PCI-SIG ENGINEERING CHANGE NOTICE

TITLE:	Flattening Portal Bridge (FPB)
DATE:	Introduced: 19 April 2016 Updated: 2 Feb 2017 PWG Approval: Final release 9 Feb 2017
AFFECTED DOCUMENT:	PCI Express Base Specification, Rev. 3.0 / 3.1 PCI-to-PCI Bridge Architecture Specification, Rev 1.2 Single Root I/O Virtualization and Sharing Specification, Rev 1.1 , PCI Code and ID Assignment Specification (current version)
SPONSOR:	Intel, Microsoft, NVidia

Figure 6-x1: FPB High Level Diagram and Example Topology

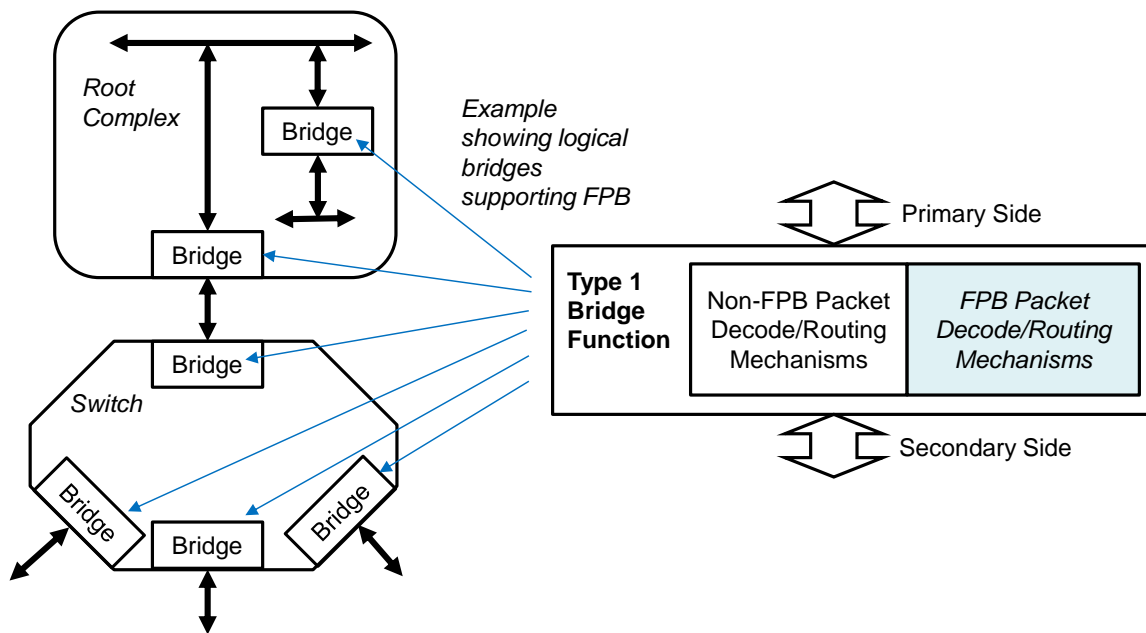
A bridge that implements the FPB capability can itself also be referred to as an FPB. The FPB capability can be applied to any logical bridge, as illustrated in <Figure 6-x1>.

Figure 6-x1a: Example Illustrating "Flattening" of a Switch

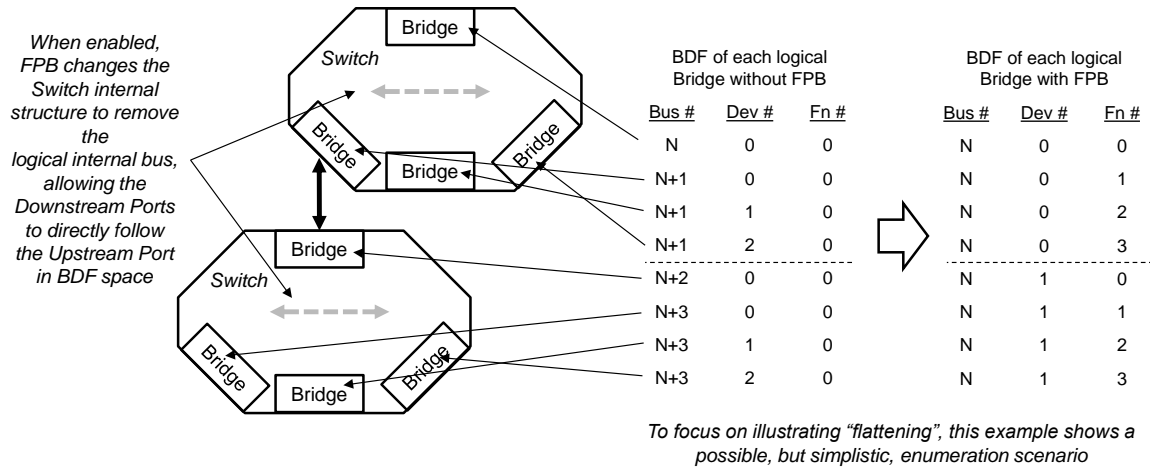
FPB changes the way Bus Numbers are consumed by Switches to reduce waste, by “flattening” the way Bus Numbers are used inside of Switches and by Downstream Ports (Figure 6-x1a).

Figure 6-x1b: Vector Mechanism for Address Range Decoding

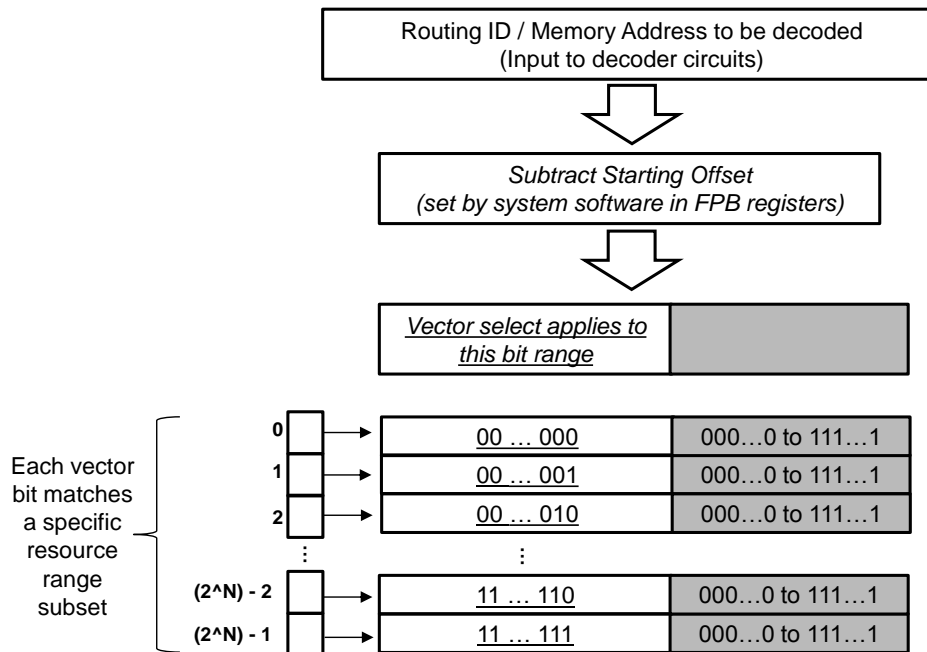
FPB defines mechanisms for system software to allocate Routing IDs and Memory Space resources in non-contiguous ranges, enabling system software to assign pools of these resources from which it can allocate "bins" to Functions below the FPB. This is done using a bit vector where each bit when Set assigns a corresponding range of resources to the Secondary Side of the bridge (see Figure 6-x1b).

Figure 6-x3: Routing IDs (RIDs) and Supported Granularities

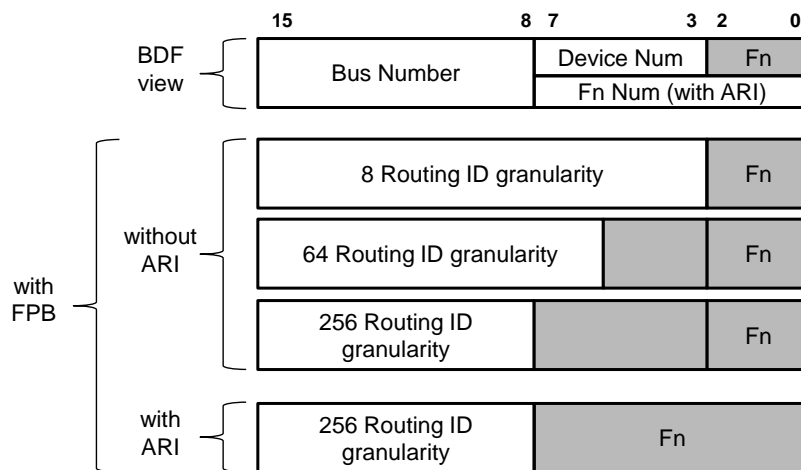
When ARI is not enabled, The FPB RID mechanism can be applied with different granularities, programmable by system software through the FPB RID Vector Granularity field in the FPB RID Vector Control 1 register. Figure 6-x3 illustrates the relationships between the layout of RIDs and the supported granularities. The reader may find it helpful to refer to this figure when considering the requirements defined below and in the definition of the Flattening Portal Bridge (FPB) Capability (see Section <7.y>).

Figure 6-x2: Addresses in Memory Below 4 GB and Effect of Granularity

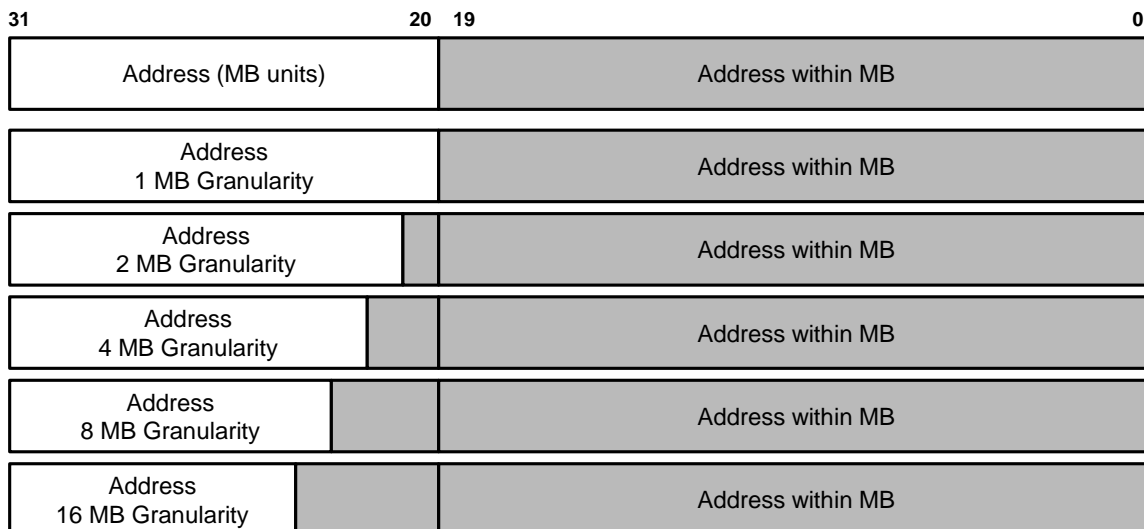
The FPB MEM Low mechanism can be applied with different granularities, programmable by system software through the FPB MEM Low Vector Granularity field in the FPB MEM Low Vector Control register. Figure 6-x4 illustrates the relationships between the layout of addresses in the memory address space below 4 GB to which the FPB MEM Low mechanism applies. The reader may find it helpful to refer to this figure when considering the requirements defined below and in the definition of the Flattening Portal Bridge (FPB) Capability (see Section <7.y>).
